Bonham's Field, Yapton

Drainage Verification Report

Project	Bonham's Field, Yapton – Plots 2-3
Document Title or Subject	Drainage Verification Report
Document Reference	104367-PEF-ZZ-XX-RP-CD-000601
Revision Reference	S2-P02
Date	18 th May 2022

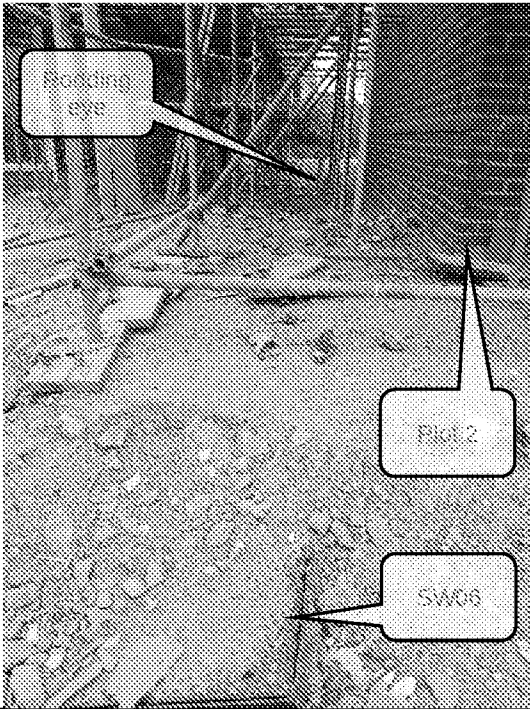
Photograph	Manhole ref (refer to 'as-built' drawing)	Comments
	SW06	Plot 2 Drainage. Unable to lift manhole due to overlying debris. Positioned in line with rodding eye to back of property. Rainwater pipe connections observed above surface on SE elevation corner and NW elevation corner as per as-built drawing.

SW08

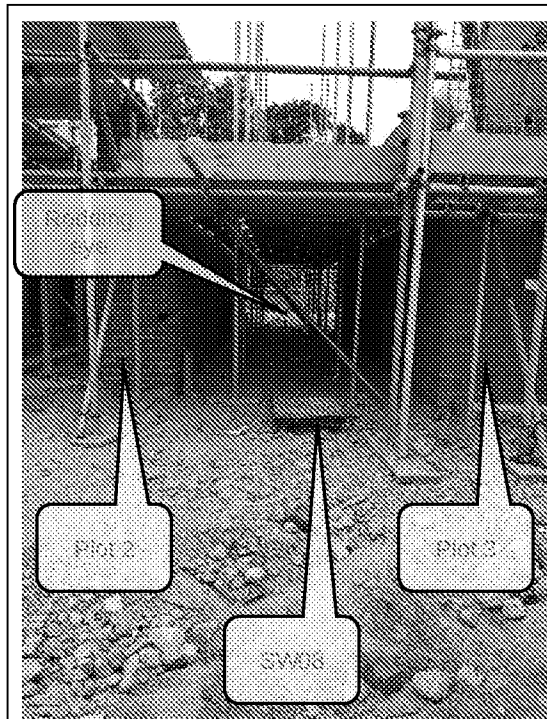
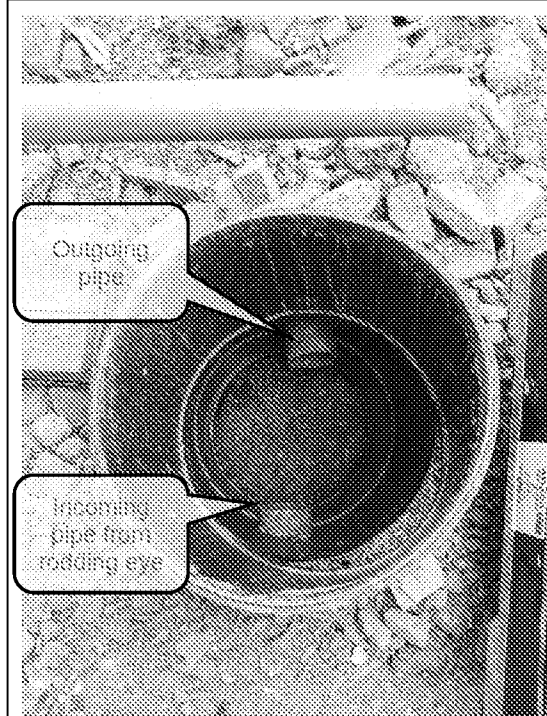
Plot 2 and 3 Drainage.

Located between Plot 2 and Plot 3. Manhole lifted (see below).

Positioned in line with rodding eye to back of property. Rainwater pipe connections observed above surface on NW elevation on Plot 2 garage, NE elevation on Plot 2 garage.

Internal photo of SW08 manhole, raised inverts to intercept debris etc prior to discharge into voided subbase. Additional PVC collar installed above manhole to limit entry of debris. Granular surround possibly present around chamber and bedding around pipes. Bedding material within chamber unknown.

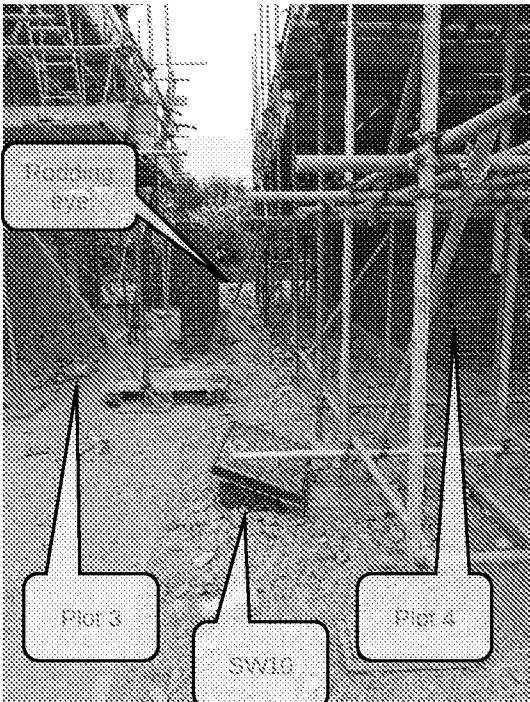
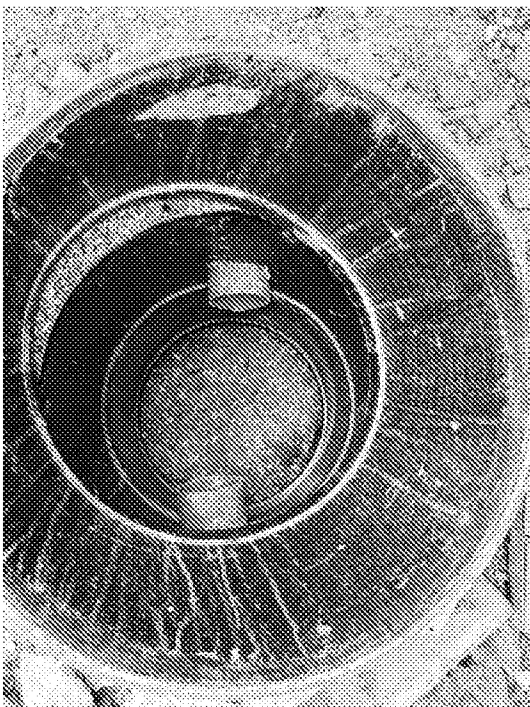
Plot 3 (and 4) Drainage. Located between Plot 3 and Plot 4. Manhole cover lifted (see below). Positioned in line with rodding eye to back of property. Rainwater pipe connections observed on NE elevation.
	SW10	Internal photo of SW10 manhole, raised inverts to intercept debris etc prior to discharge into voided subbase. Additional PVC collar installed above manhole to limit entry of debris. Granular surround possibly present around chamber and bedding around pipes. Bedding material within chamber unknown.

Appendix A As Built Drainage Drawing

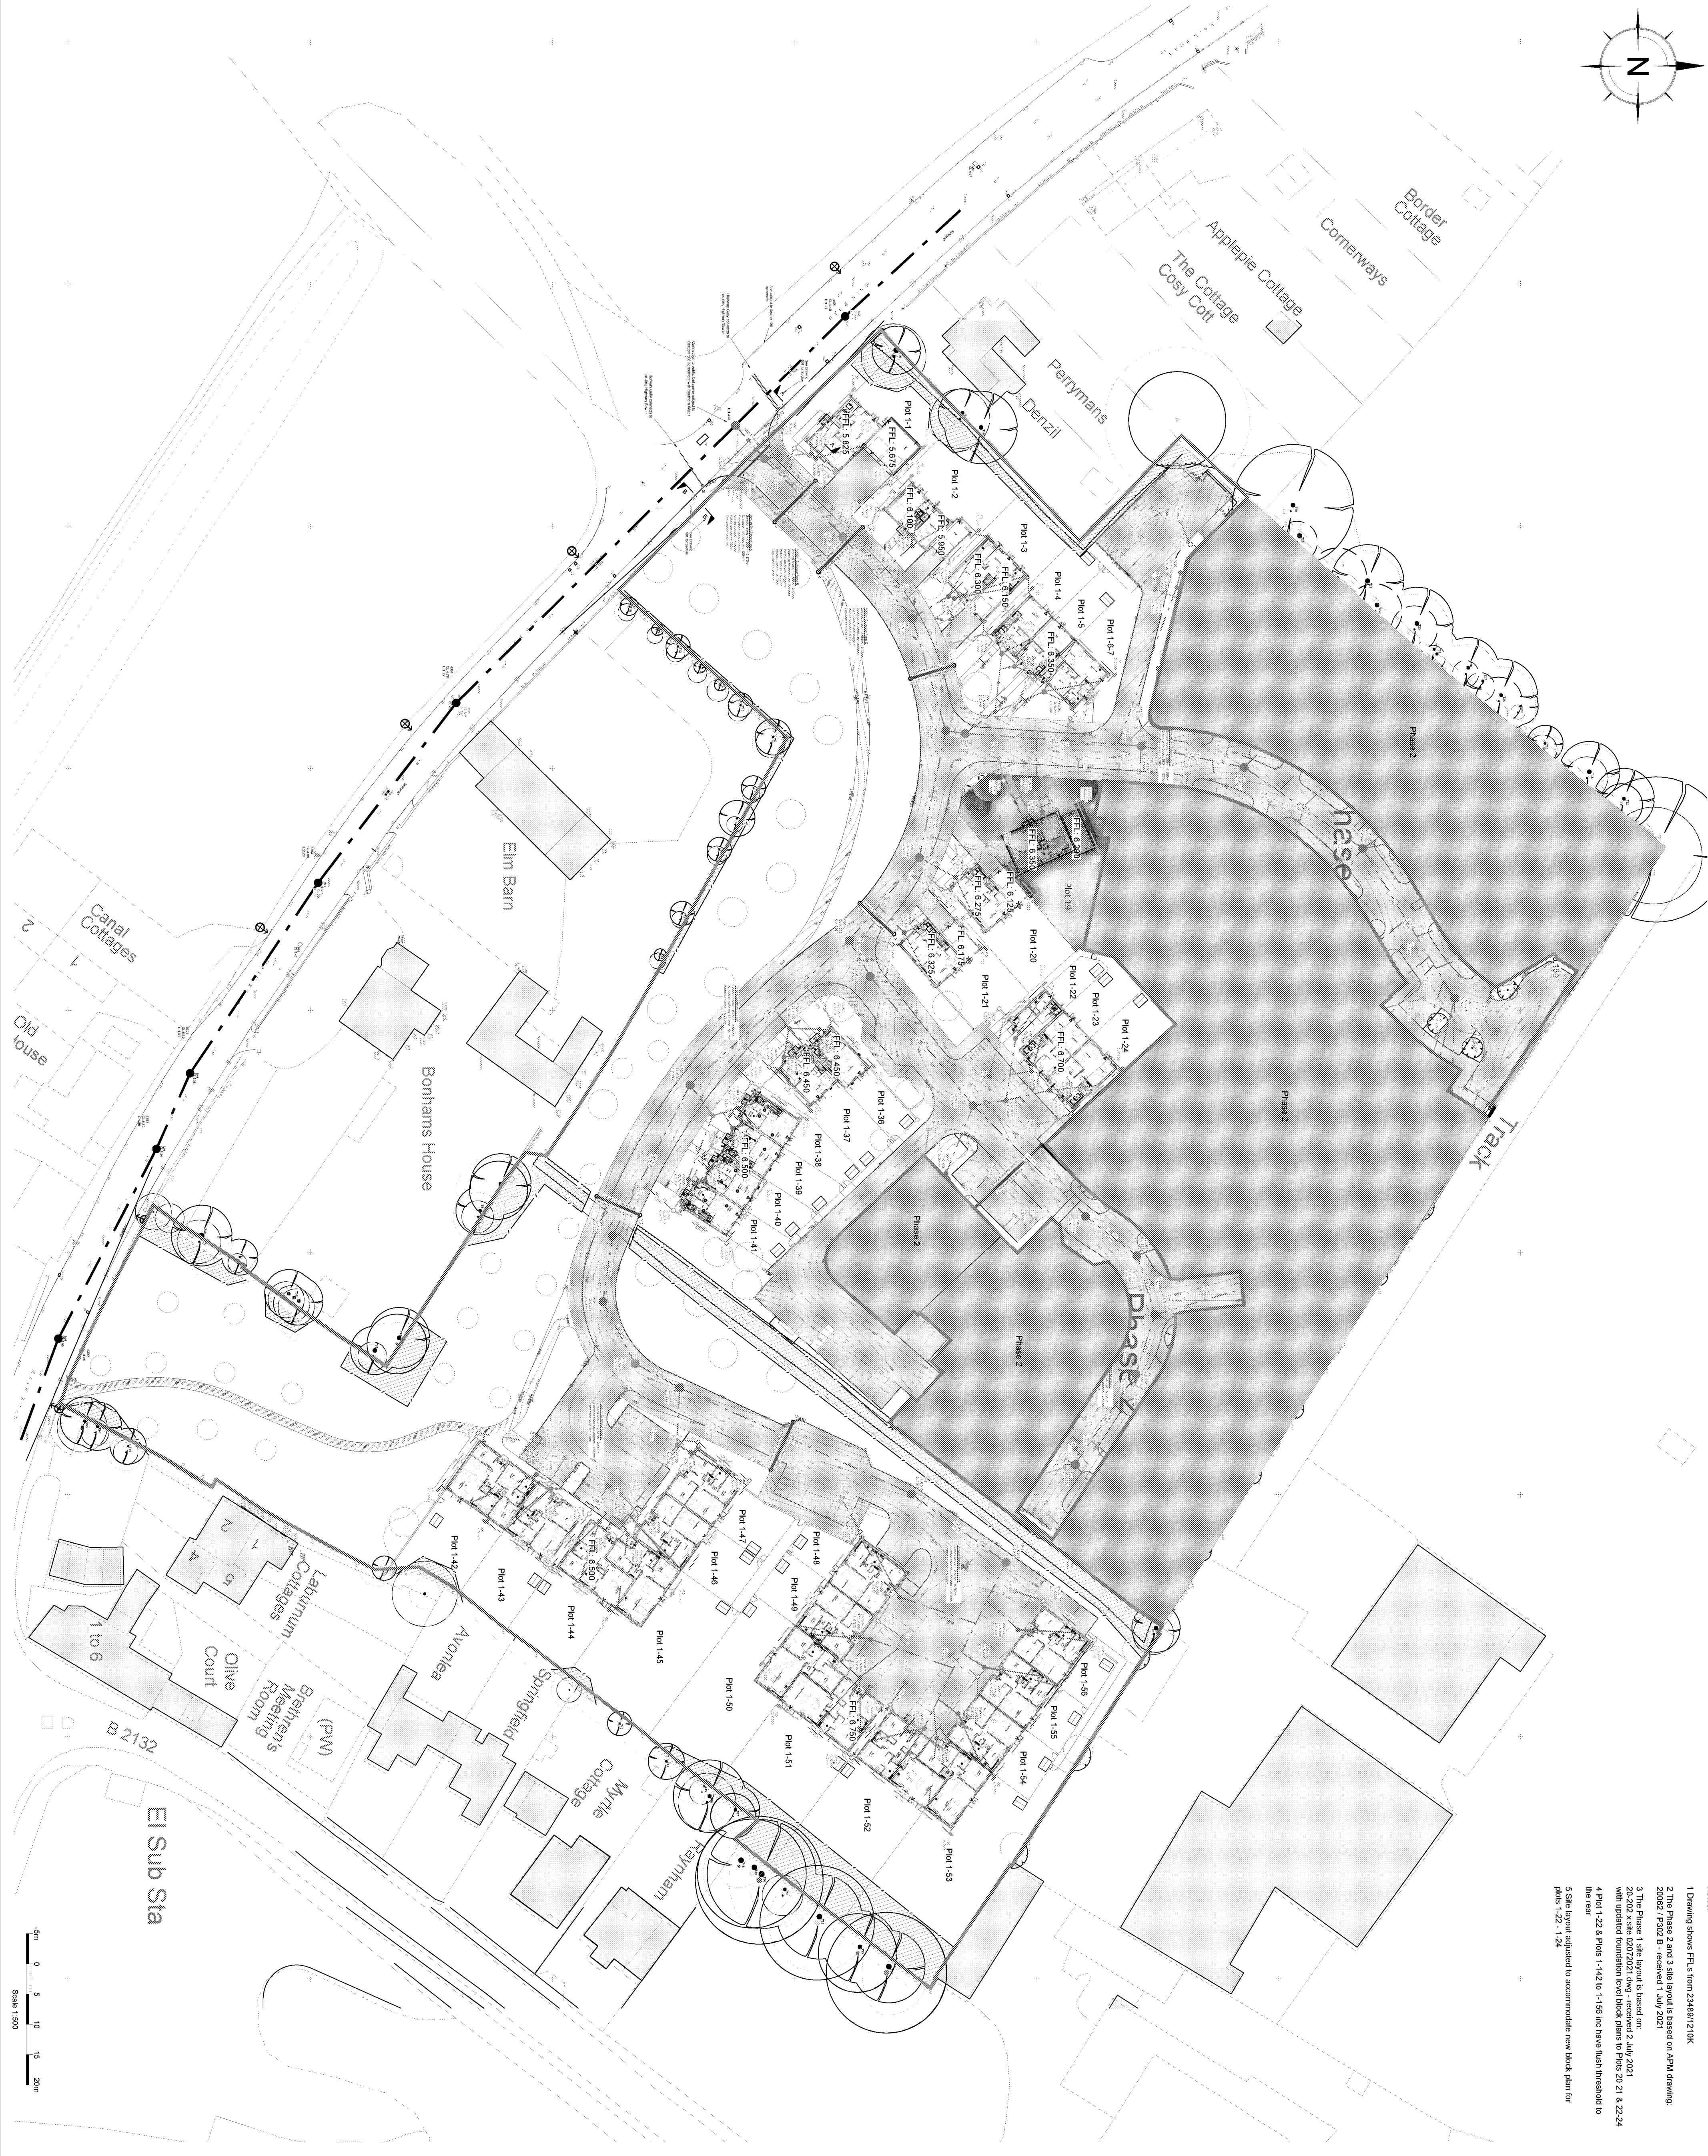
- 3.2.5 The 'As Built' drainage plan (included as **Appendix A**) shows both 100mm and 150mm surface water pipework are designed to a general minimum of 1:167. It is understood that this has been used to ensure cover is achieved at the upstream end of each surface water run as connections into diffuser tanks located within voided subbase are approximately 600mm deep for the most part.

- 3.2.7 The pipe run between plots 2 and 3 (upstream and downstream of SW06) that would fall under private homeowner ownership does not meet the Building Regulations requirement, but does meet with the BS EN 752-2008 requirement, where a 1:150 diameter pipe is laid as a 1:167 gradient, giving a maximum velocity of 0.77m/s.

- 3.3.5 Plots 2 and 3 drain to voided subbase Area C. The impermeable area as measured off the as-built drawing draining to this area remains in line with the calculations prepared by The Civil Engineering Practice as part of the Discharge of Conditions Technical Note. It should be ensured that no other drainage from roofs or impermeable area is connected to the voided subbase Area C in line with the original design.

- Catchment E - 5.775m AOD
 - Catchment F - 5.980m AOD
 - Catchment G - 5.980m AOD
 - Catchment H - 6.000m AOD
- 3.3.7 On the as-built drawings, there is a minor variation from this, with the invert level of the diffuser tank in Catchment E set to 5.735m AOD (40mm lower than agreed) and Catchment F set to 5.935m AOD (45mm lower than agreed). Catchment G and H are reported on the as built drawings as per the agreed levels.
